From: Terry Scanlan [TScanlan@spfwater.com]
Sent: Wednesday, September 29, 2010 9:32 AM
To: Weaver, Mathew
Cc: Carol MacGregor
Subject: RE: Belvidere Hot Springs - WR Permits 65-13912 & 13913
Attachments: MacGregor Test Plan.pdf; MacGregor Test Data; Geological 2-26-09.pdf

Subject: Geothermal Well Test Schedule - Permit 65-13913 (Carol MacGregor)

Subject: Test Plan for Permit 65-13913
Carol MacGregor – Geothermal Well

RE: Test Plan for Permit 65-13913
Carol MacGregor – Geothermal Well

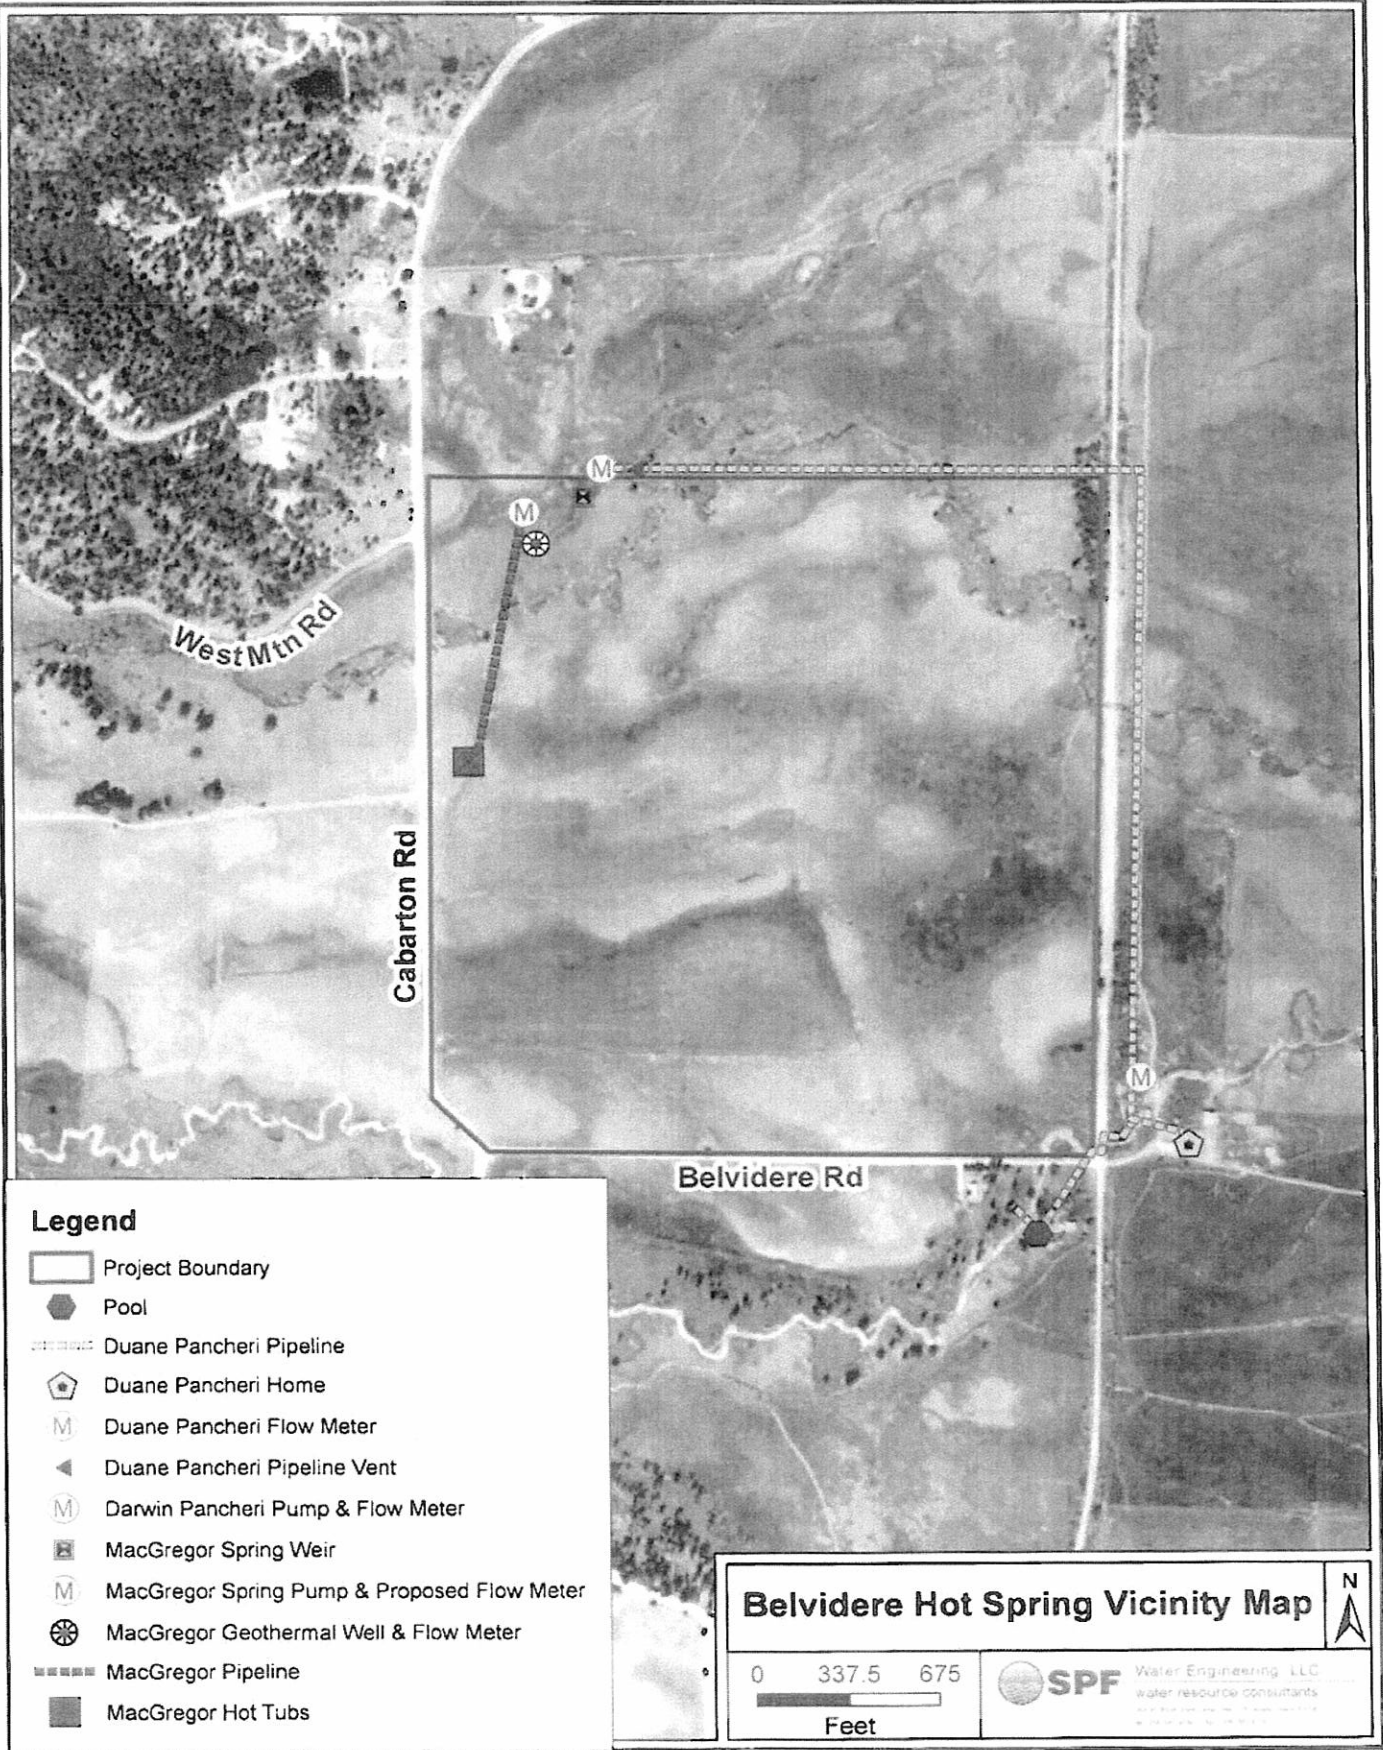
1. *Provide basic sketches and labeling of the MacGregor and Pancheri water systems relating to the test data measurement points, places of use, diversions, pumps, flowmeters, valving, etc. See attached schematic.*
2. *The proposal states that ground water will be discharged into a ditch downstream from the spring intakes. Provide information showing the discharge location will not influence test data measurement. The discharge from the well pump will be piped to the existing irrigation ditch that is located east of the springs. Past monitoring demonstrates that hot spring flows (as reflected by Pancheri pipeline flow rate) do not increase when the irrigation ditch is filled. On the contrary, flow rates normally decline during the summer and increase in the fall and winter. Therefore, discharge of pumped water to the ditch is not anticipated to impact test measurements.*

- Provide basic sketches and labeling of the MacGregor and Pancheri water systems relating to the test data measurement points, places of use, diversions, pumps, flowmeters, valving, etc.
- The proposal states that ground water will be discharged into a ditch downstream from the spring intakes. Provide information showing the discharge location will not influence test data measurements.
